From: T BLACK <tkb540@aol.com>
Sent: Tuesday, June 08, 2021 3:52 PM
To: Jeanne Black
Cc: scarter@placesassociates.com; lindsay.donovan24@gmail.com; ckbii@townisp.com; planning; conservation; conservation2; planning2
Subject: Re: Joanne Dr.

Subject: Joanne Dr.

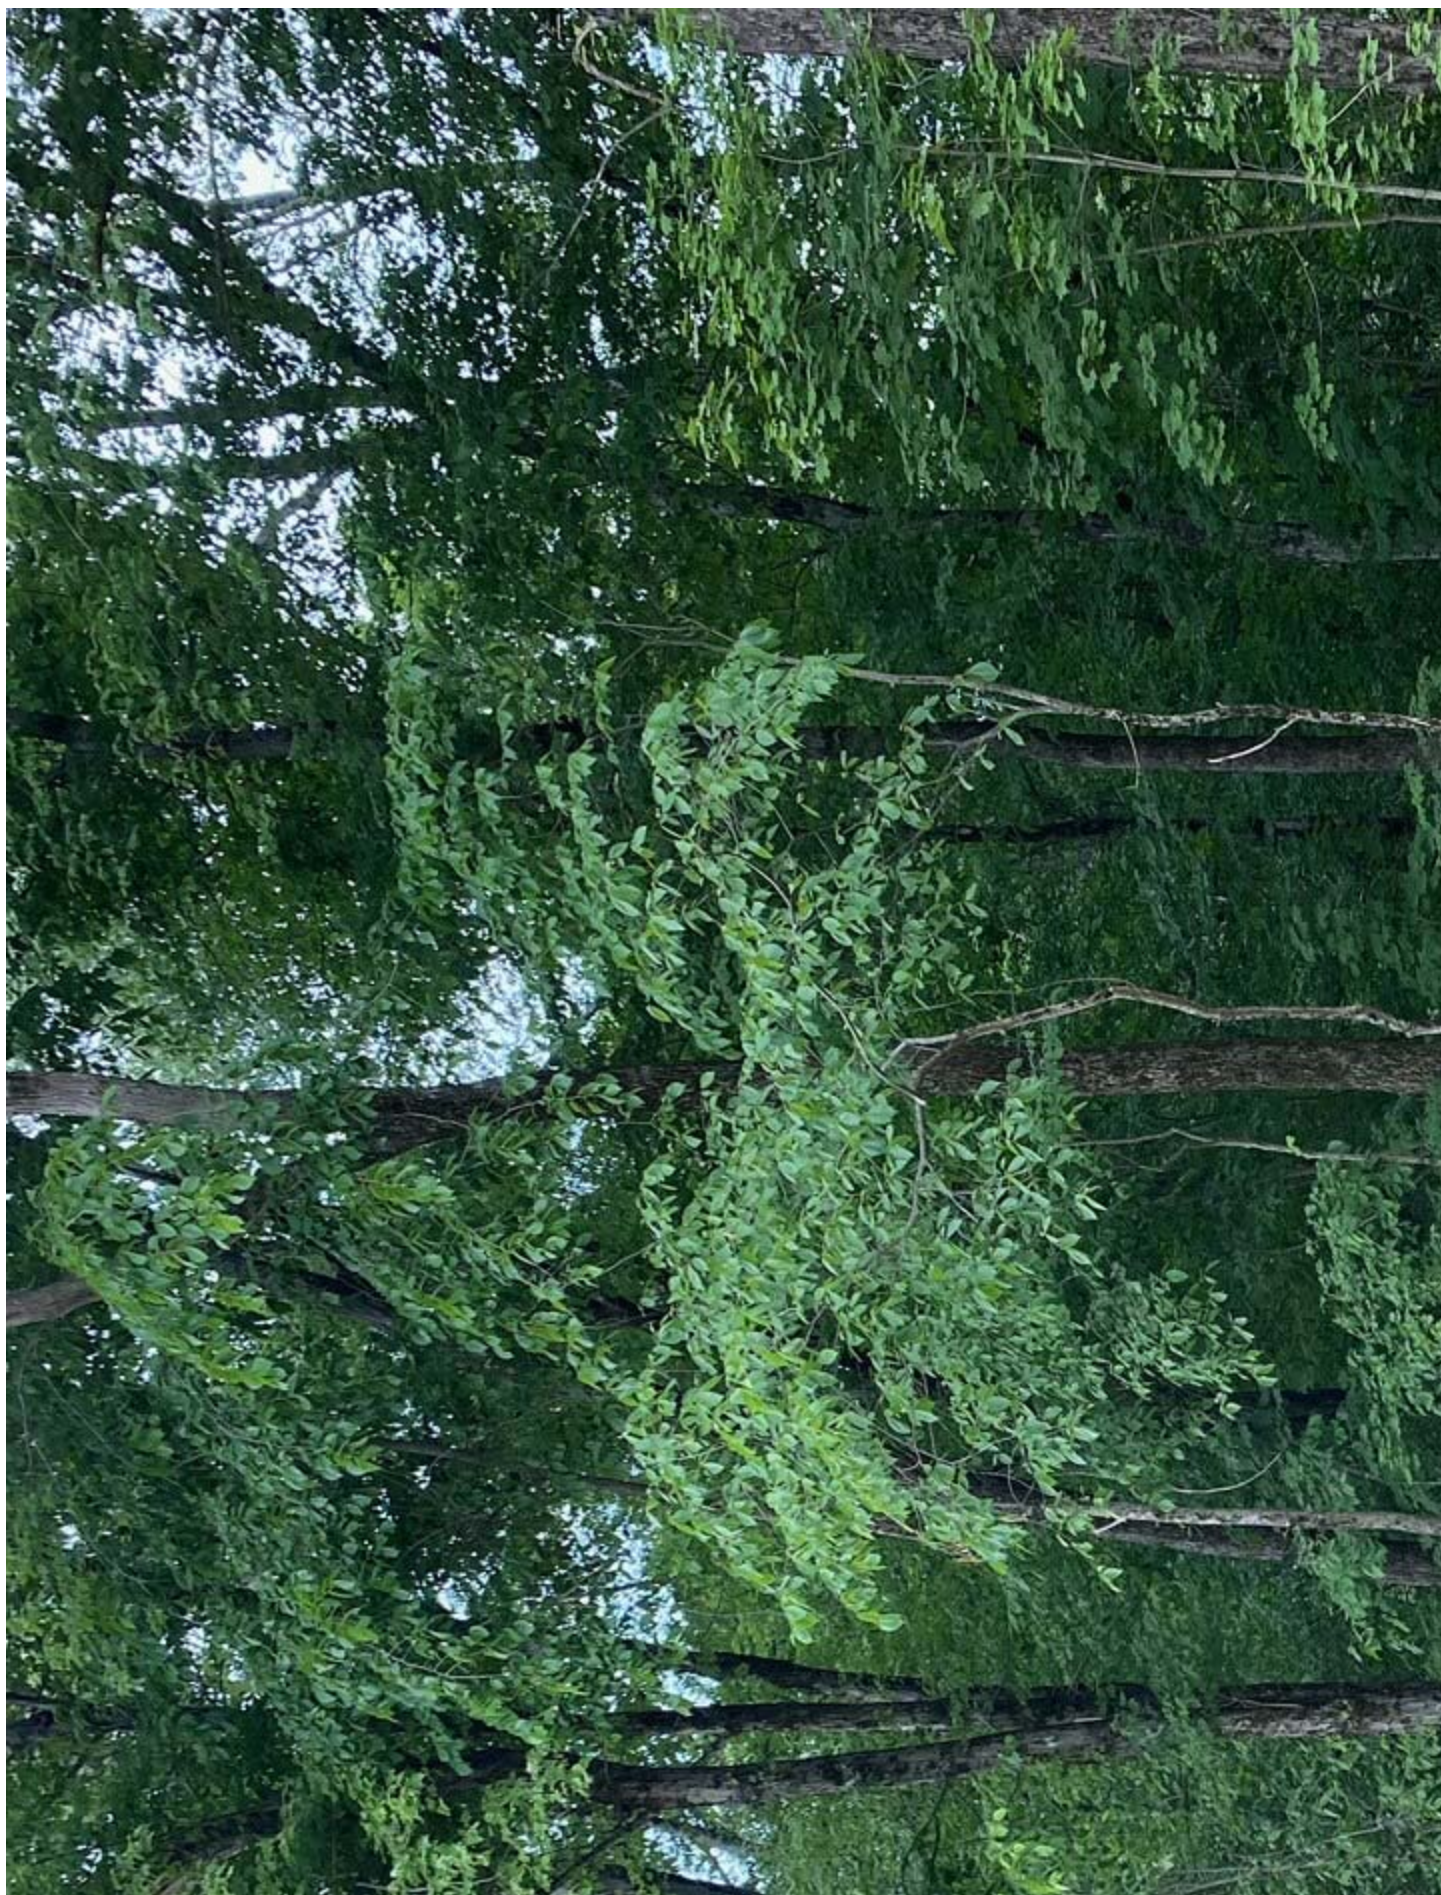
Lot 1 needs the stone temporary construction entrance installed for access to the lot. Given the fill in the front yard, I recommend siltation barrier at the toe of slope so the material does not wash into the roadway. Given the predicted thunderstorms, I do not understand why the electrical trench was left open, leading directly from the house to the road.

Last time I was on site, the shoulders had some loam and stump grindings for temporary stabilization. Since then the electrical trenches were installed. When will these shoulders be regraded and compacted again? I noticed the transformer near CB-3 looks low compared to the finish grade of the edge of pavement, especially when the berm and shoulder grades are considered. You might want them checked before they put in the pad for the transformer.

Hello everyone , please see the attached pictures of work completed before the rain today.

Gary and Crew did a great job preparing the wetland crossing with new silt fence and hay bales. They also added silt fence check dams per Sue's recommendation . Lot 1 electric was inspected this afternoon and backfilled immediately. The site has been compacted and stump grindings added to the tow of slope on lot 1 and across lot 2 entrance.
